**ATTACHMENT A
FOR
PROPOSED BUILDING STANDARDS
OF THE
DIVISION OF THE STATE ARCHITECT (DSA-AC)

REGARDING PROPOSED CHANGES TO
THE CALIFORNIA BUILDING CODE
CALIFORNIA CODE OF REGULATIONS, TITLE 24, PART 2

2016 CALIFORNIA BUILDING CODE
INTERVENING CODE CYCLE**

Figure 11B-404.2.4.3
Maneuvering Clearances at Recessed Doors and Gates

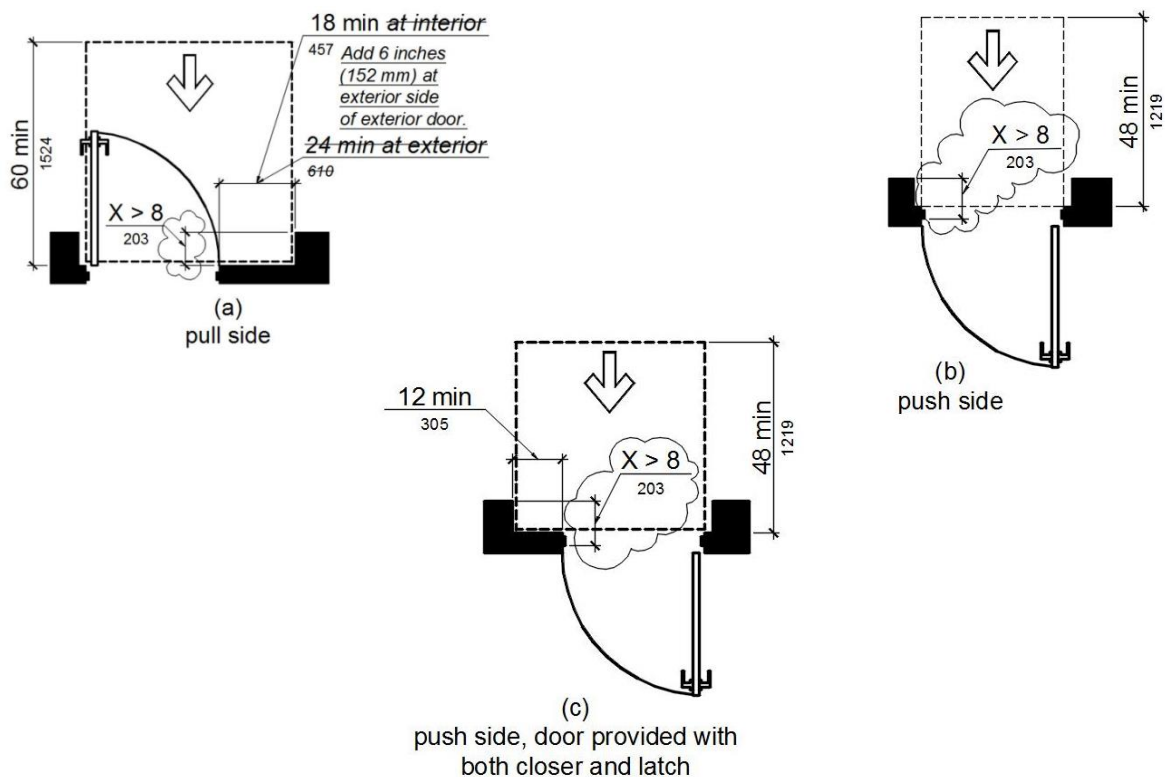
CBC Section 11B-404.2.6 requires maneuvering clearance for forward approach when any obstruction within 24 inches of the latch side of an exterior doorway projects more than 8 inches beyond the face of the door; this requirement is illustrated in Figure 11B-404.2.4.3(a). However, the maneuvering clearance dimensions for the strike side clearance width are not consistent with Figure 11B-404.2.4.1(a) which illustrates the required maneuvering clearance for forward approach at an exterior door which is not recessed. DSA proposes to amend the latch side clearance width dimension in Figure 11B-404.2.4.3(a) to be consistent with Figure 11B-404.2.4.1(a); this dimension will read: "18 min" followed by "Add 6 inches (152 mm) at exterior side of exterior door."

**FIGURE 11B-604.7.2
DISPOSAL UNIT LOCATION**

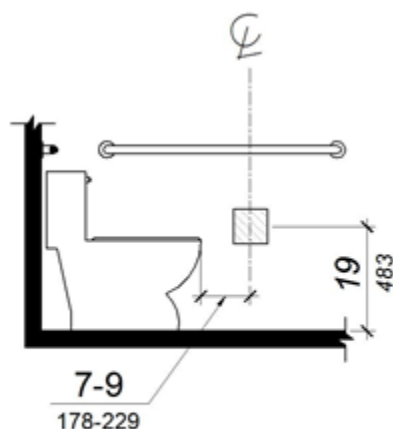
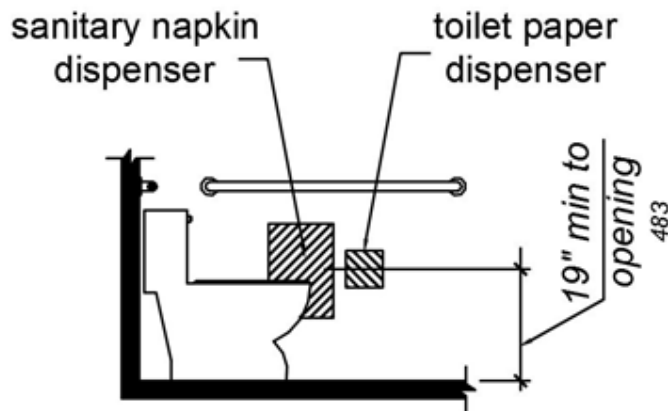
DSA received a specific request to address placement of sanitary napkin disposal units to be in a location accessible to a user of the water closet. DSA is proposing to reorganize Section 11B-604.7 to move the existing requirements of Section 11B-604.7 into a new subsection 11B-604.7.1 and add a new subsection 11B-604.7.2 with new requirements for sanitary napkin disposal units.

DSA is proposing a related change to renumber Figure 11B-604.7 to Figure 11B-604.7.1 and add a new figure 11B-604.7.2 illustrating the new requirements for sanitary napkin disposal units.

- The title of Figure 11B-604.7 will be changed to Figure 11B-604.7.1. Figure 11B-604.7.2 will be added to the California Building Code.

Figure 11B-703.7.2.1
International Symbol of Accessibility

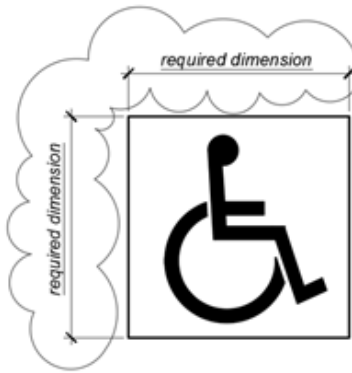
DSA has received a number of questions about whether a border is required around the ISA in various locations (e.g. at entrances, elevators, toilet rooms and bathing rooms, check-out aisles, and parking spaces). In response, DSA notes the text of the building code does not require a border around the ISA. DSA is proposing to add permissive language to Section 11B-703.7.2.1 which allows a border to be provided at any ISA – either inside or outside the applicable minimum required ISA dimension.

DSA is also proposing to amend Figure 11B-703.7.2.1 to address general confusion about whether the size of an ISA is to be measured to the extent of the person and wheelchair graphic or to the rectangular boundary depicted in Figure 11B-703.7.2.1. DSA's amendment adds dimension lines with the text "required dimension" to indicate the minimum required size of the ISA is to be measured to the boundary. This is consistent with the code text which requires the ISA to "...comply with Figure 11B-703.7.2.1."

Figure 11B-705.1
Size and Spacing of Truncated Domes

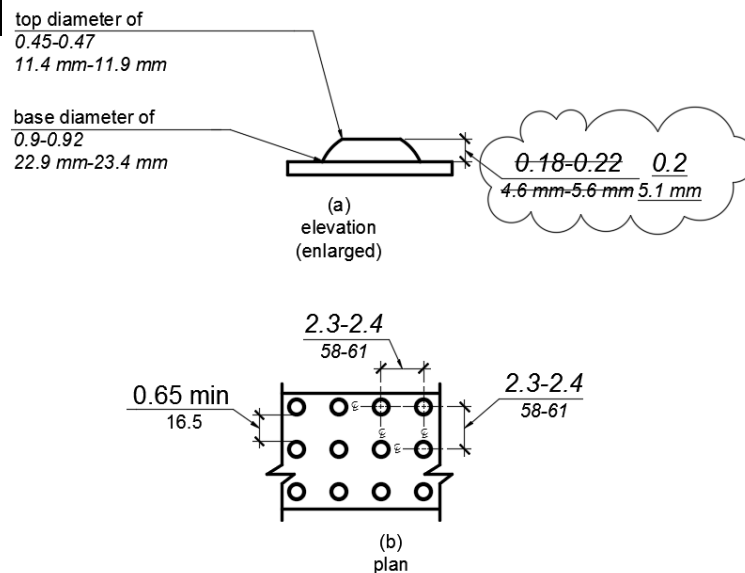
inadvertently neglected to make the corresponding change to Figure 11B-705.1(a). DSA is proposing to amend Figure 11B-705.1(a) to correspond with Section 11B-705.1.1.1. The revision occurs to the dimension in the figure for the height of the truncated domes. The proposed amendment will align the dimension in the figure to the code text.
